# Citizens Committee to Complete the Refuge

23 September 2024

Re: Recirculated Draft Environmental Assessment Cargill, Incorporated Solar Sea Salt System Maintenance and Operations Activities

Figure 206. Riprap Placed on Outboard Side of Berm

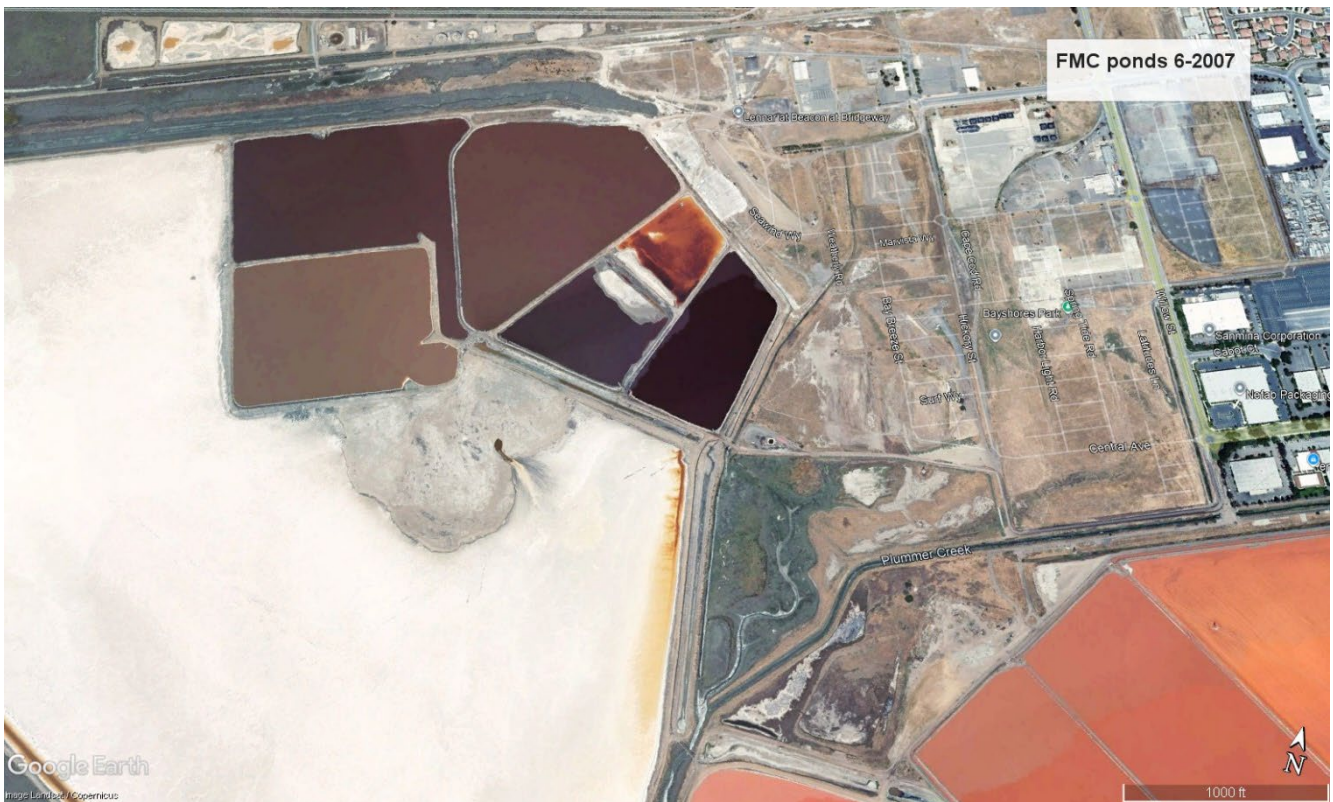
The image above is taken from the Draft EA. What monitoring if any, will be required when new riprap is placed on the outboard side of levees? This particular photo is concerning as the new riprap is placed right up to existing tidal wetlands habitat. It must be required, if new riprap is installed

instead of utilizing NBS, that the impacts of the riprap on adjacent tidal wetland be monitored. That a corrective action plan be developed for the review and approval of regulatory and resource agencies, and that corrective measures be implemented. If corrective action is not possible, compensatory mitigation should be required and should be at a ratio that considers permanent loss of existing habitat and the temporal loss that will occur until the mitigation area has met its success criteria.
